Wisconsin Department of Transportation

**Proposal #01: 1517-07-77, WISC 2016 229
 USH 10 – USH 10/STH 441
 County CB – Oneida Street
 USH 10
 I-41 Interchange Bridges and
 LLBDM Bridge B-70-61 Redeck
 Winnebago County**

Letting of July 12, 2016

This is Addendum No. 01, which provides for the following:

Addendum No. 01
 ID 1517-07-77
 Revised Sheet 34
 June 23, 2016

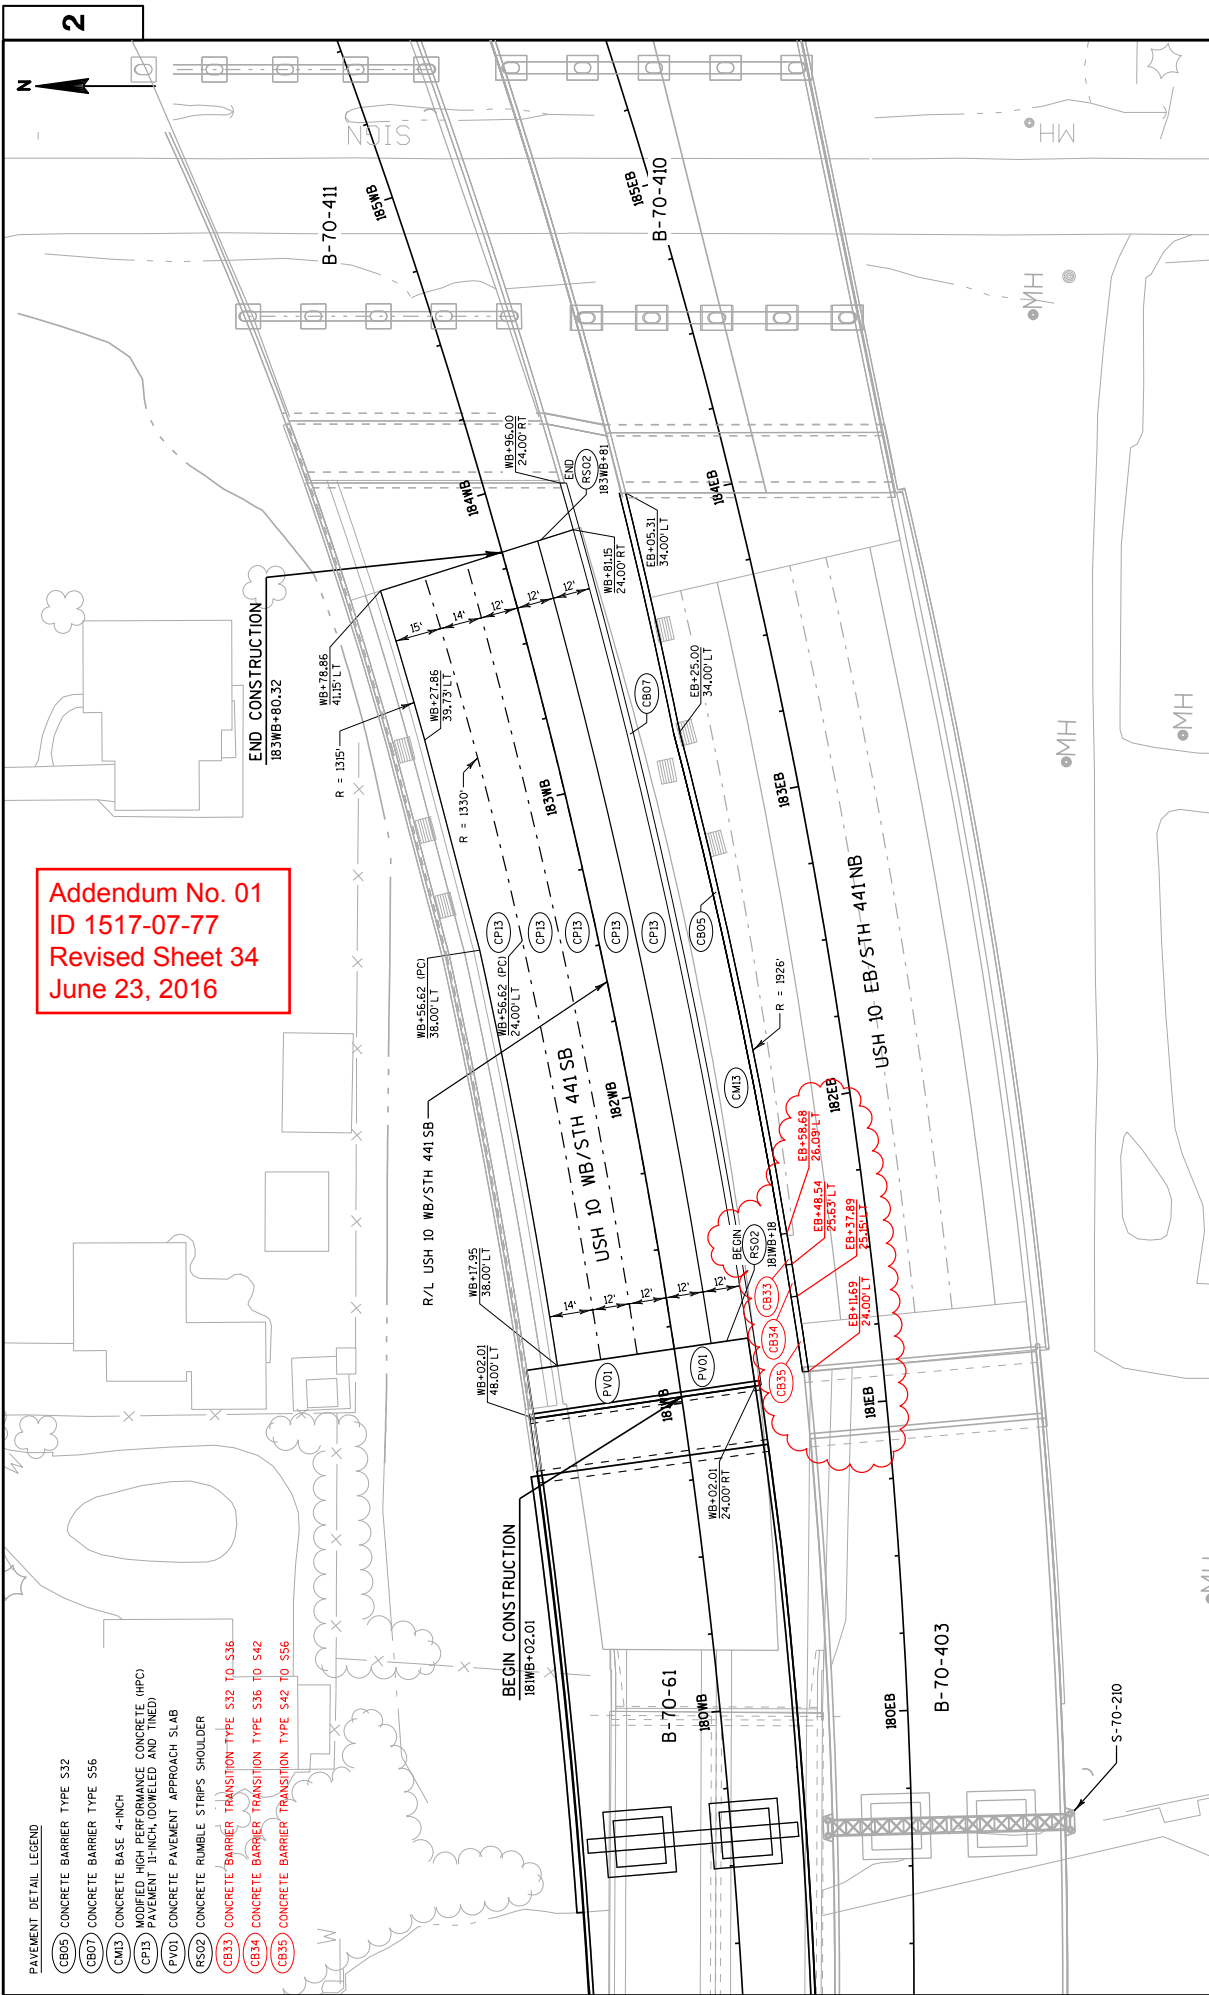
Revised Plan Sheets	
Plan Sheet	Plan Sheet Title (brief description of changes to sheet)
34	Plan Details (Updated barrier transitions)
53	Erosion Control (updated EB median inlet protection)
101	Traffic Control Stage 1 (updated notes)
102	Traffic Control Stage 1 (updated notes)
112	Traffic Control Stage 2 (Changed sheet number)
143	Miscellaneous Quantities (Updated barrier quantities)
146	Miscellaneous Quantities (Updated inlet protection quantities)
148	Miscellaneous Quantities (Updated traffic control and left in place quantities)
149	Miscellaneous Quantities (Updated temporary pavement marking quantities)
162	Miscellaneous Quantities (updated Traffic control detour sign quantities)
163	Miscellaneous Quantities (updated Traffic control detour sign quantities)
418	General Plan And Elevation Spans 7-12 (Added Temp. Shoring and Note)
419	General Notes And Quantities (Updated Quantities)
436	Pier 8 Layout (Changed Bearing Centerline)

BEARING PEDESTAL
DETAILS
PIER 8

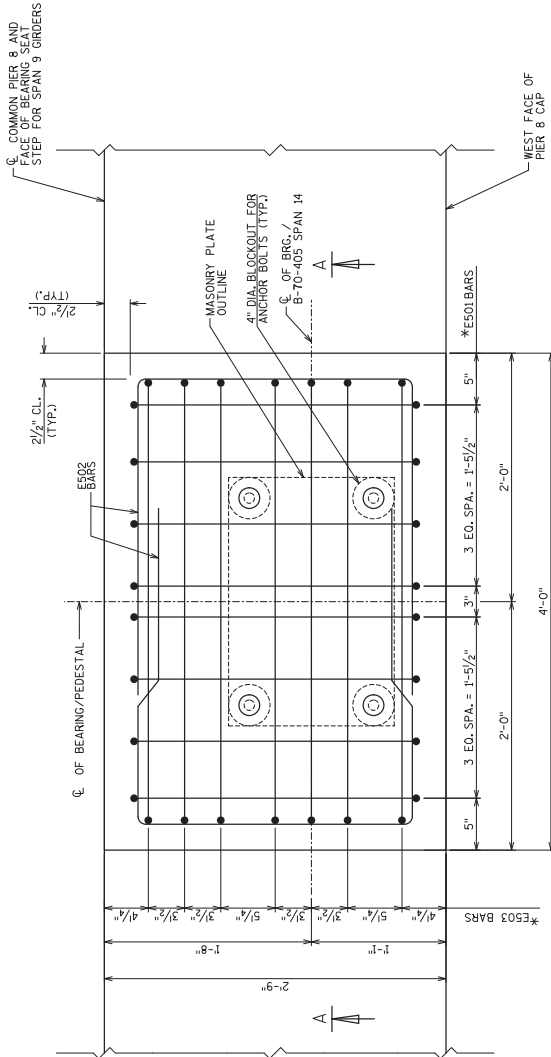
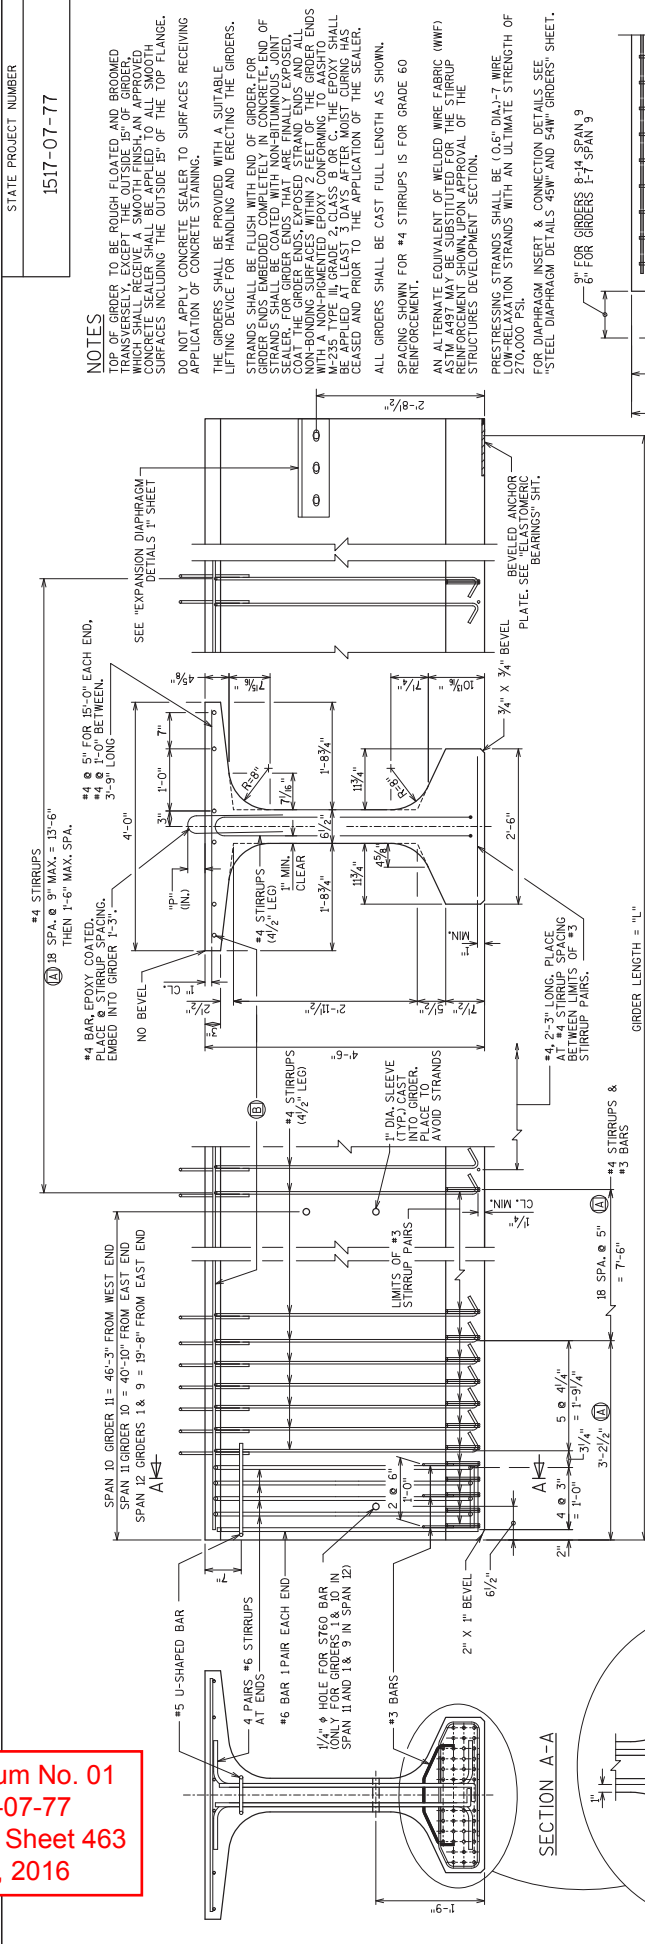
454	Bearing Pedestal Details Pier 8 (Updated Bearing & Pedestal Dimensions)
463	54W" Prestressed Girder Details 1 (Span 12 girder lengths changed)
498	General Plan And Elevation Spans 1-3 (Updated Pile Notes and Table)
499	General Plan And Elevation Spans 4-7 (Elevations)
500	General Plan And Elevation Spans 8-11 (Added Temp Shoring at Pier 11)
501	General Plan And Elevation Spans 12-14 (Added Temp Shoring, Added Detail A for common pier 8, Shifted Bearing Line)
502	General Notes And Quantities (Updated Quantities, Added paint color note)
508	West Abutment Plan & Elevation (Updated wing wall width, added and corrected legend, added line work)
509	West Abutment Details (Added notes, pile numbers, SS901 Bars)
510	West Abutment Wing 1 (Wing body width and notes)
511	West Abutment Wing 2 (Wing pile shifted, underdrain moved, added notes)
512	West Abutment Bill Of Bars (Updated Rebar)
513	Piers 1-3 Layout (Pier Dimensions)

Addendum No. 01
ID 1517-07-77
Revised Sheet 545
June 23, 2016

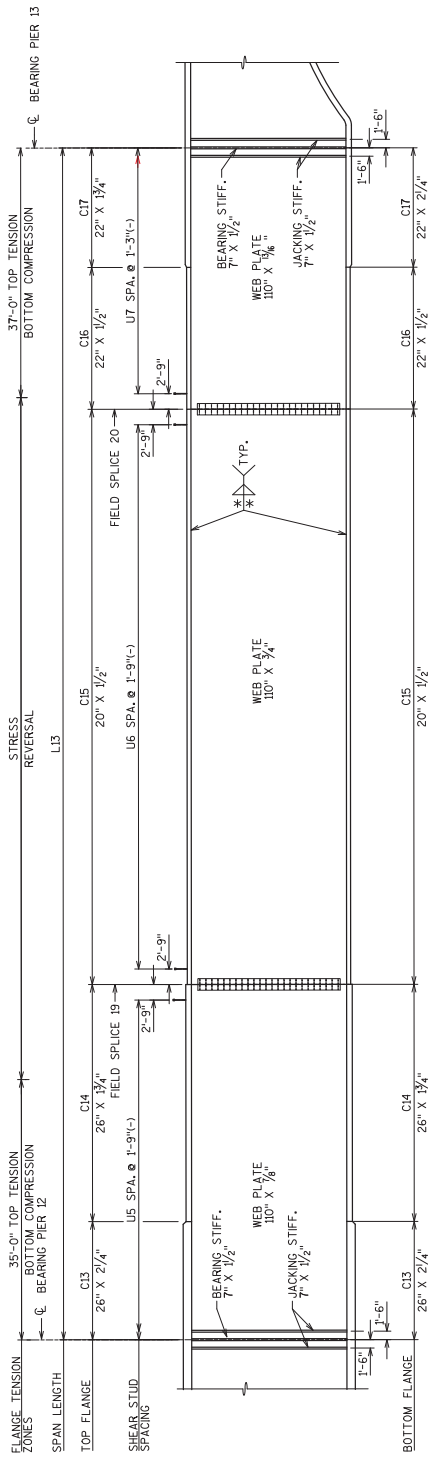
528	Piers 1-4 Footing Pile Layout (Length Table updated and added pile prebore symbol)
529	Piers 5, 7-9 Footing Pile Layout (Updated Pile tables and number of PB609 Bars)
531	Piers 10-13 Footing Pile Layout (Updated Pile tables and number of PC613 Bars)
532	Bearing Layout Unit 1 (Added Reference Line And Note)
533	Bearing Layout Unit 2 (Added Reference Line And Note)
534	Bearing Layout Unit 3 (Added Reference Line And Note)
539	Framing Plan And Elevation Spans 1-2 (Dimensions And Text Revisions)
540	Framing Plan And Elevation Spans 3-4 (Dimensions And Text Revisions)
541	Framing Plan And Elevation Spans 5-6 (Dimensions And Text Revisions)
542	Framing Plan And Elevation Spans 7-8 (Dimensions And Text Revisions)
543	Framing Plan And Elevation Span 9 (Dimensions And Text Revisions)
544	Framing Plan And Elevation Spans 10-11 (Dimension And Text Revision)
545	Framing Plan And Elevation Span 12 (Dimension And Text Revision)

Addendum No. 01
ID 1517-07-77
Revised Sheet 547
June 23, 2016

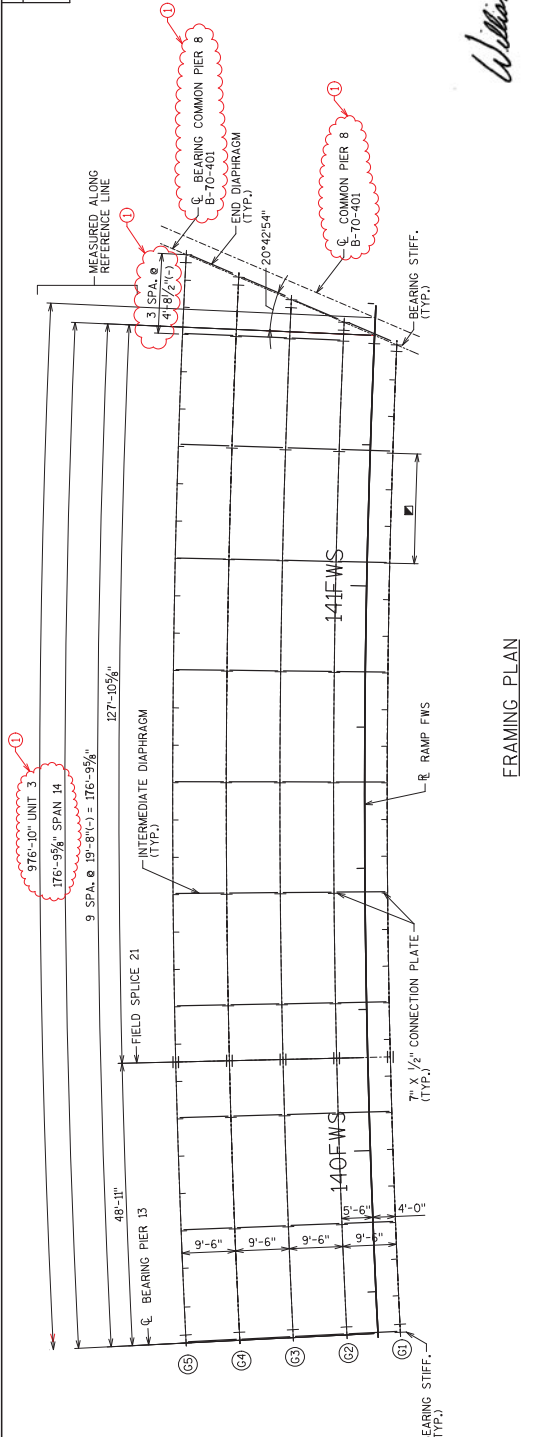
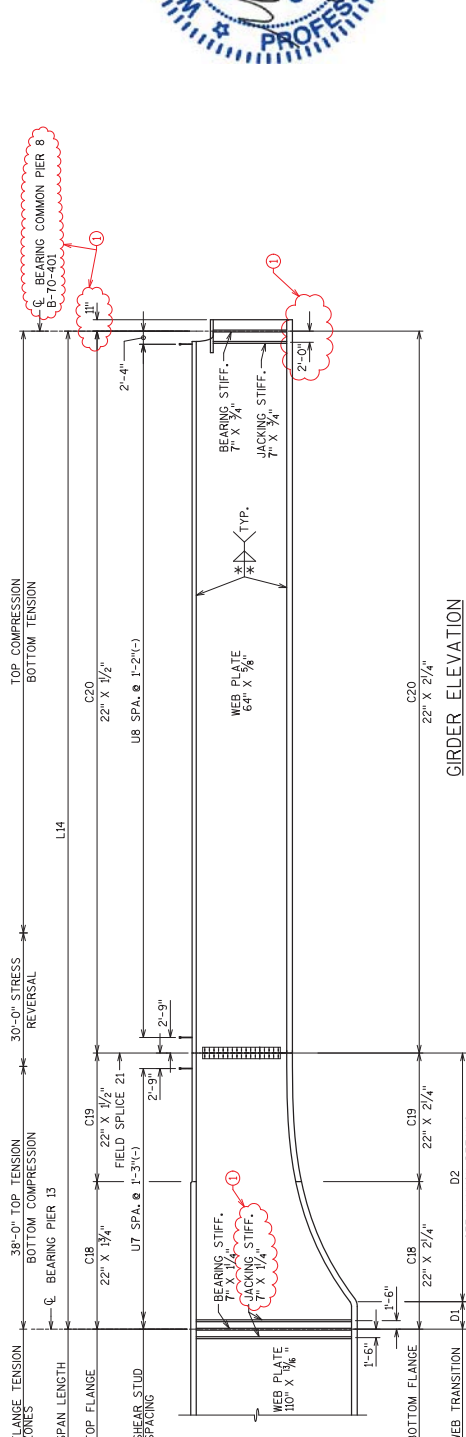
546	Framing Plan And Elevation Span 13 (Dimension And Text Revision)
547	Framing Plan And Elevation Span 14 (Dimension And Text Revision)
559	Deck Reinforcement Unit 1 (Number Of Bars And Spelling)
560	Deck Reinforcement Unit 2 (Number Of Bars And Spelling)
561	Deck Reinforcement Unit 3 (Number Of Bars And Spelling)
562	Superstructure Details & Bill Of Bars (Updated Rebar Quantity)
566	Deck Pour Sequence Unit 3 (Updated Span 14 Length)
571	Parapet Electrical (Updated Electrical Fitting Details)
572	Structural Approach Slab Details (Updated notes, moved SS901 Bar Bill to Abutment Sheets)
573	Modular Exp. Joint Details 1 (Updated Shared Pier 8 joint No. of cells and movement per 10°F)
574	Modular Exp. Joint Details 2 (Updated dimensions and notes)
575	Reinforcing At Expansion Joint Units 1, 2, & 3 (Updated M408 bar length and M403 spacing at edge of deck)
576	Modular Joint Cover Plates 42SS Parapet (Added general note)

Addendum No. 01
ID 1517-07-77
Revised Sheet 578
June 23, 2016

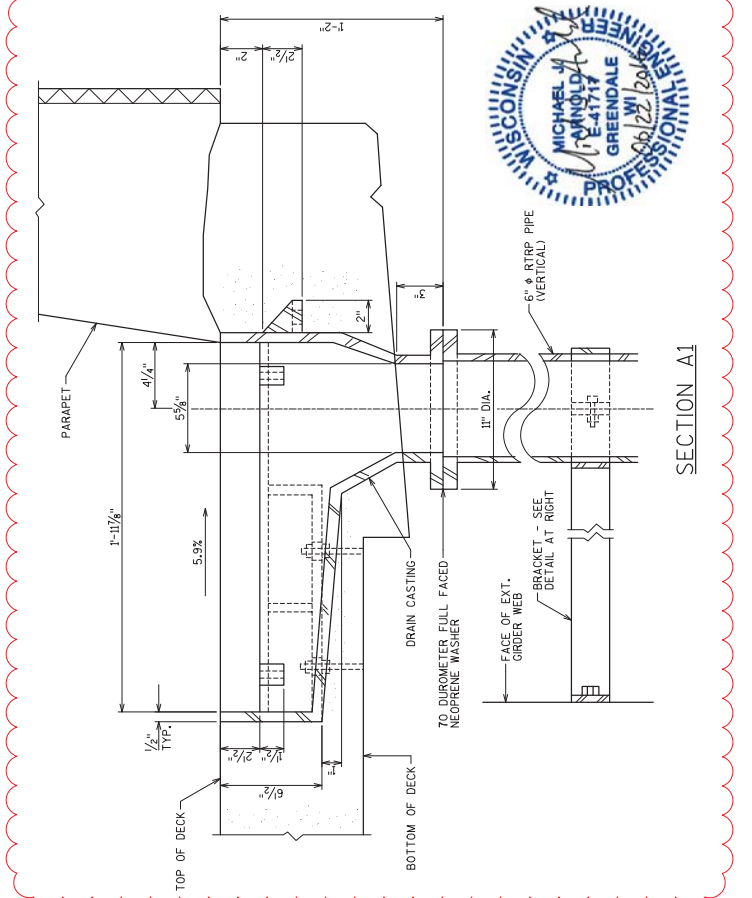
577	Modular Joint Cover Plates 32SS Parapet (Added general note)
578	Floor Drain Type 'GC' (Updated Section A1 and Section A2)
579	Downspout Details (Modified thread Insert Embedment for inserts and detail for Elevation View for Horizontal Runs)
582	Standpipe System Details (Threaded rods and inserts)
648	General Plan And Elevation (Updated Foundation Data)
649	Cross-Section (Updated cross-section dimensions; added IH 41 profile)
650	General Notes And Quantities (Modified Estimated Quantities table)
652	Pier 2 Details 1 (Updated bar reinforcement)
653	Pier 2 Details 2 (Updated bar reinforcement)
654	Bearing Pedestal Details (Updated bar reinforcement)
